Item 01 - GA Elevation update

NORTH ELEVATION UPDATE OVERVIEW

ADDITIONAL PARTIAL SOUTH ELEVATIONS

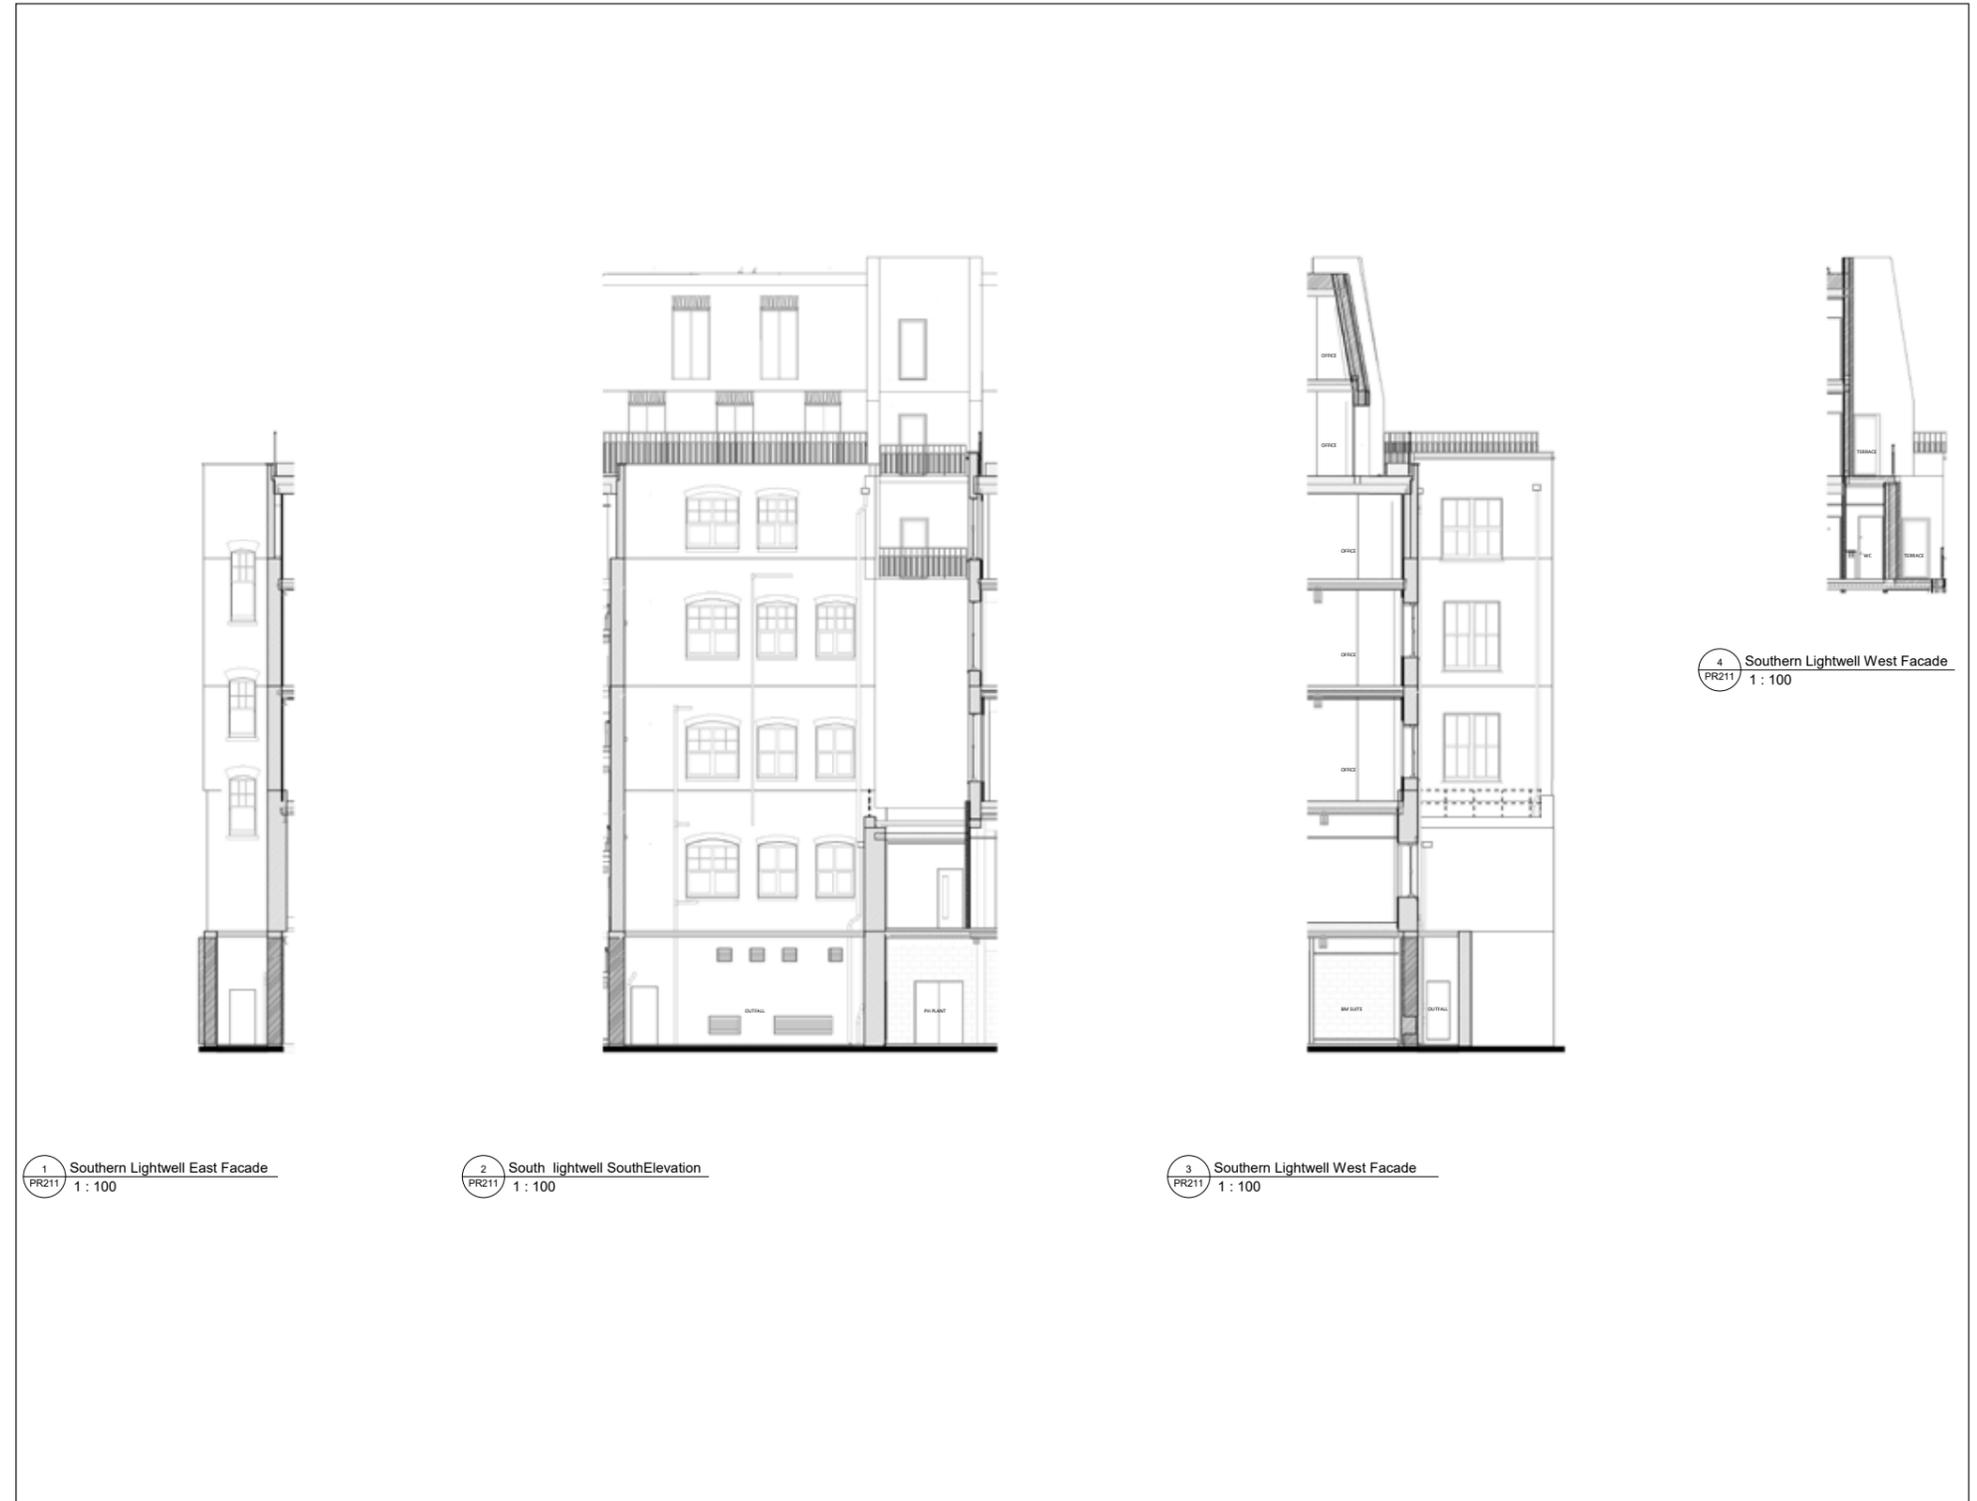
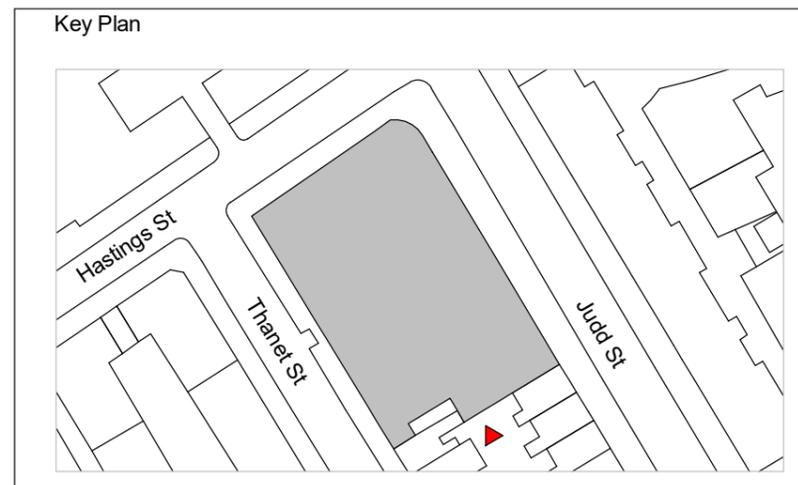
- + Additional partial elevations provided for further clarity of arrangements to flank walls where not visible in approved elevations & in Southern lightwell
- + See plans for elevation location references

DEVELOPMENT OF MAIN CORE ARRANGEMENT

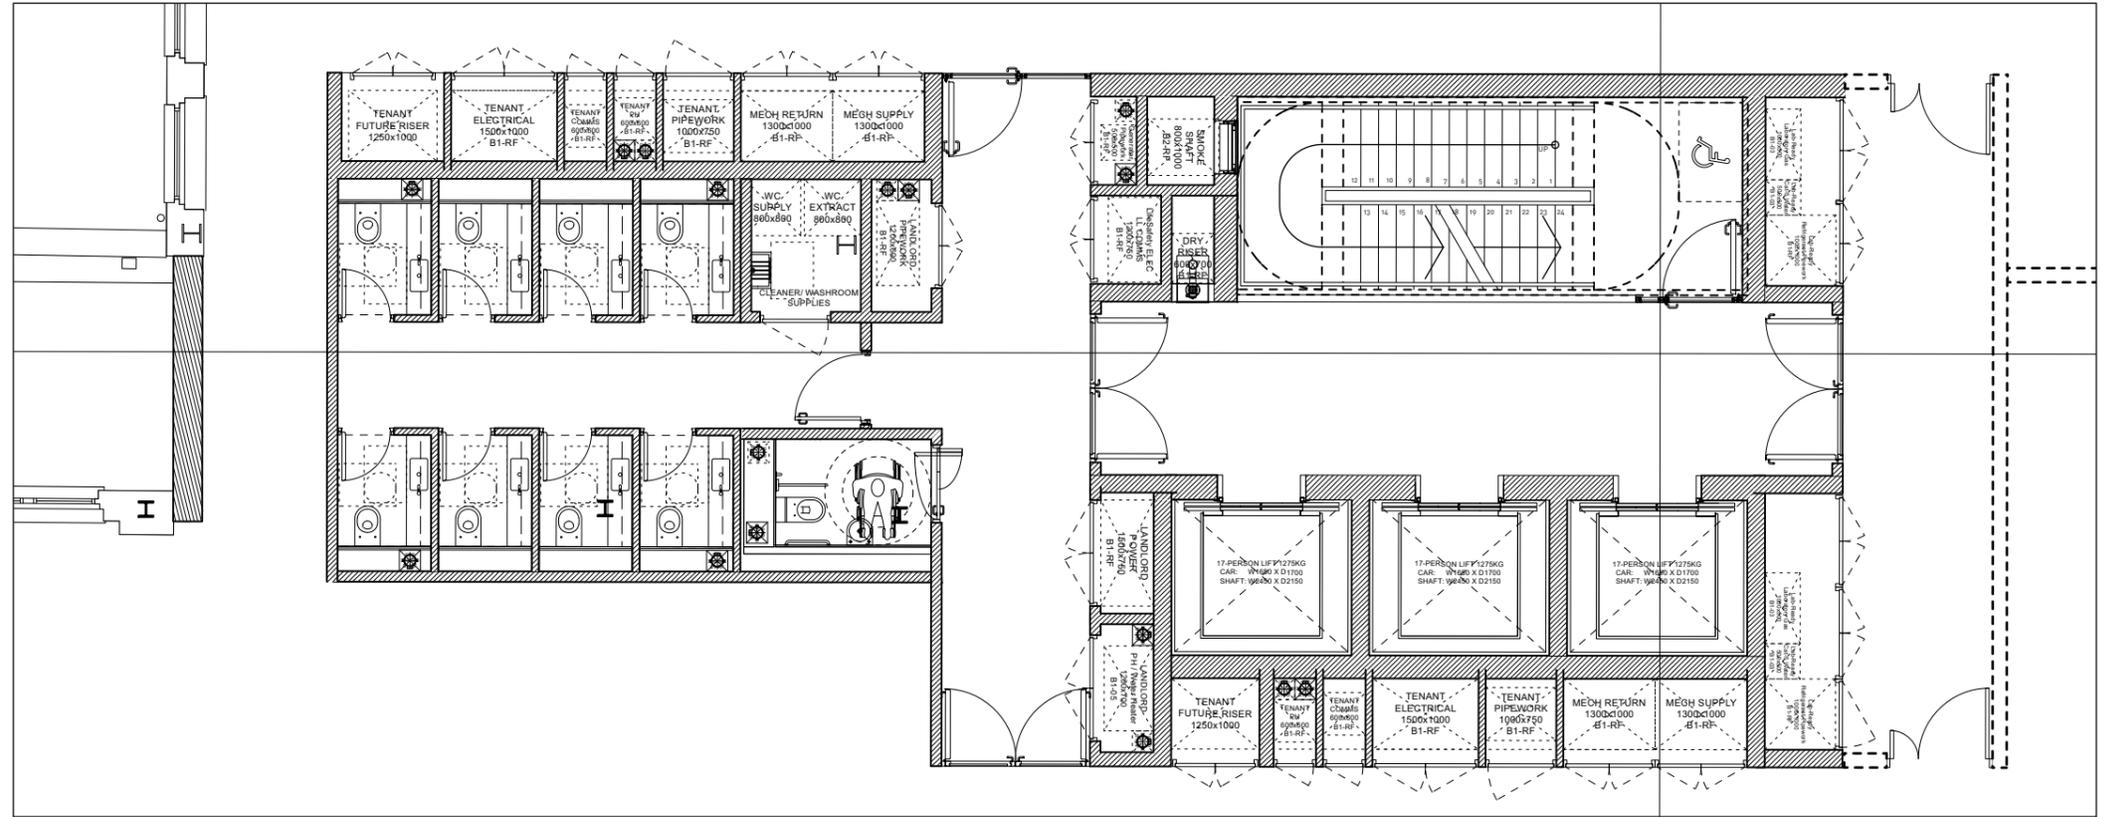
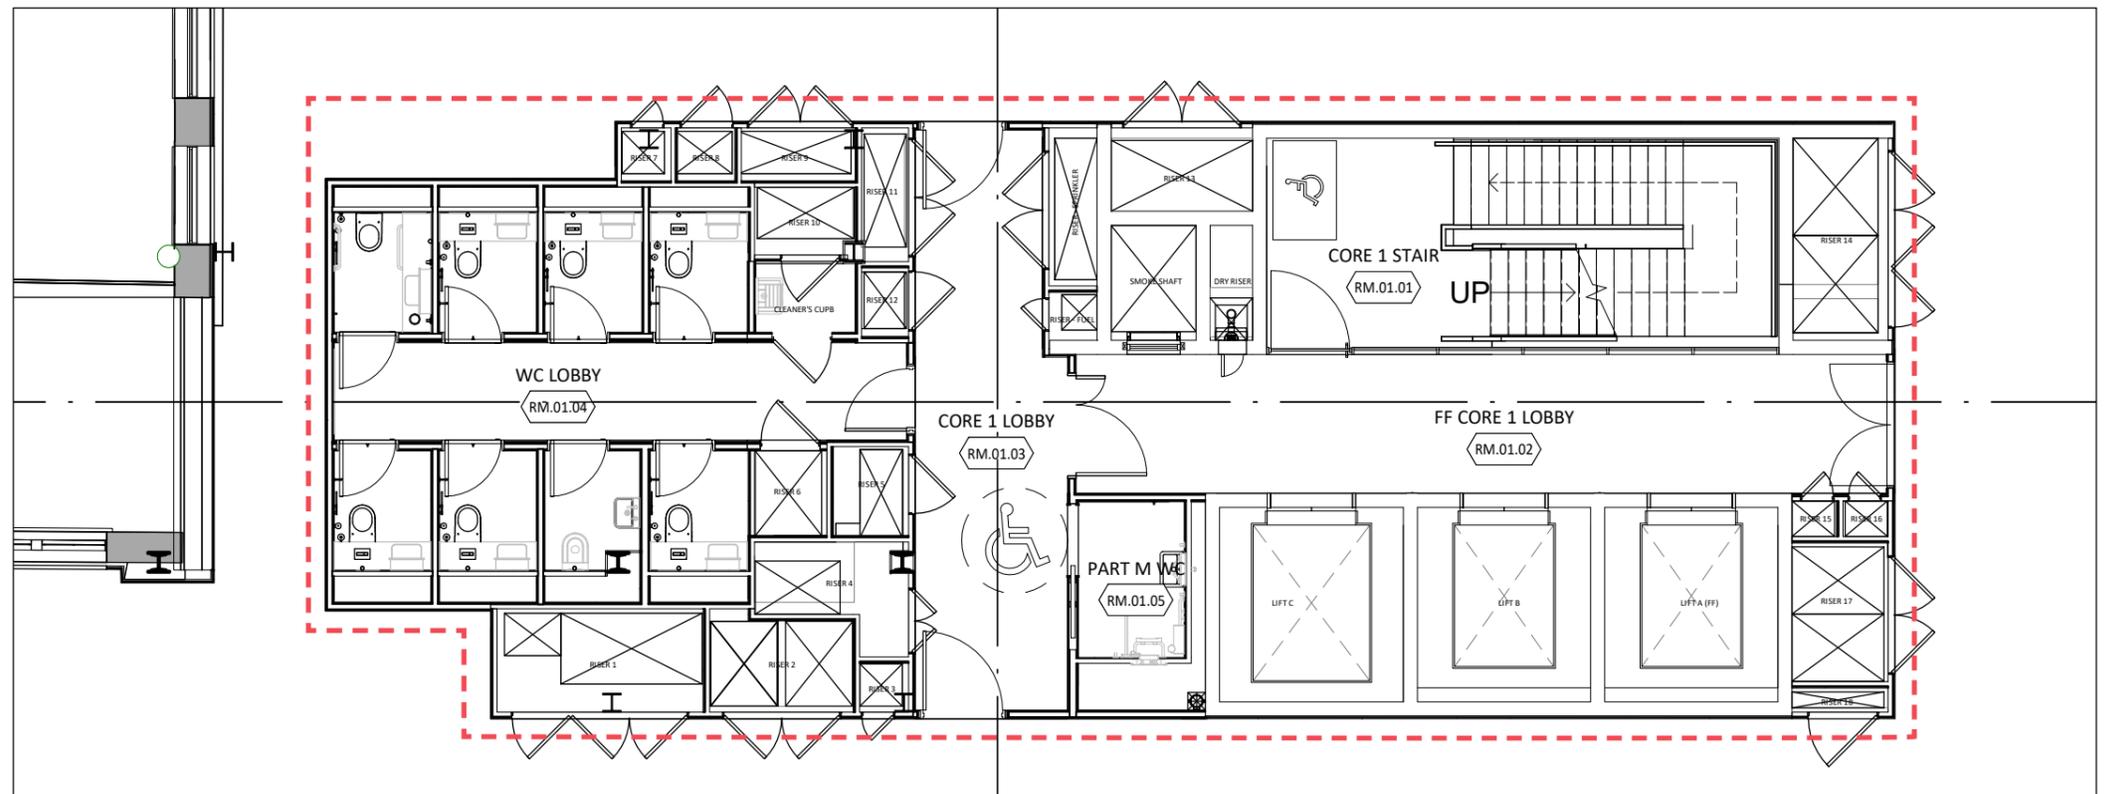
- + Stair direction flipped to rationalise escape diagram
- + Risers arrangement & sizing adjusted to reflect detailed services design development
- + Lift shaft setting out adjusted to suit detailed lift design developed
- + WC arrangement developed for better accessibility and coordination with service riser layout
